MIL-M-28787/190A
AMENDMENT 1
31 March 1993

MILITARY SPECIFICATION

MODULES, STANDARD ELECTRONIC

BUFFER-LIMITER, ANALOG, KEY CODE BAC

FIGURE 9. Offset voltage test, offset voltage drift with temperature check, and bias current (Ib) check test circuit for table VI.

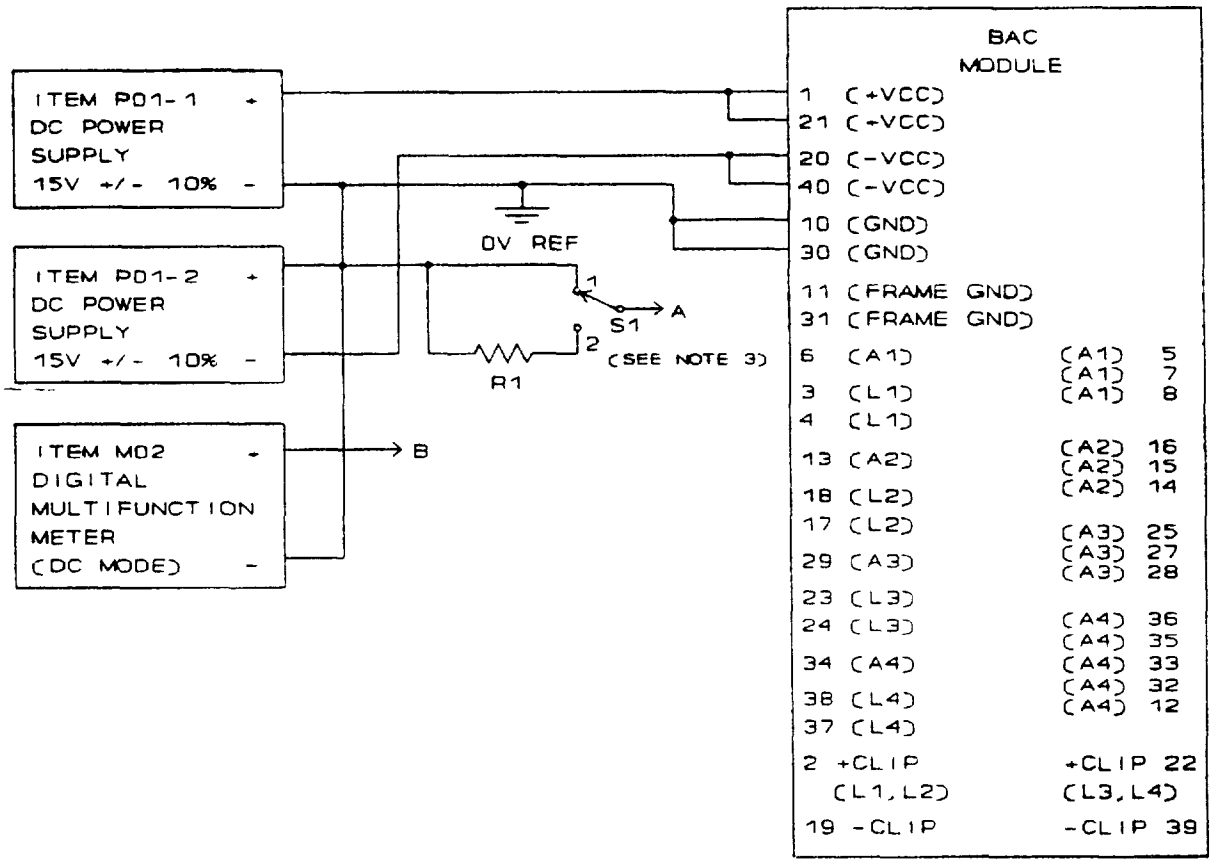
FIGURE 9: Delete and substitute new figure 9 as printed on page 2 of this amendment.

1. R1 = 1 MΩ ± 1%, 1/8 W.

2. S1 = SPDT switch.

3. Set switch S1 to position 1 for test conditions E1-E4 and F1-F4 and to position 2 for test conditions G1-G4.

4. V_{OUT} = -5.0 mV minimum, 5.0 mV maximum for test conditions E1-E4.

5. The G1-G4 limits confirm a maximum voltage change of 4.0 mV.

6. $\text{Drift} = \frac{[VOS\ (t = 0°C) - VOS\ (t = 60°C)]}{60°C}$

7. $I_b = \frac{[VOUT\ (S1 = \text{Position } 1) - VOUT\ (S1 = \text{Position } 2)]}{1\ M\Omega}$
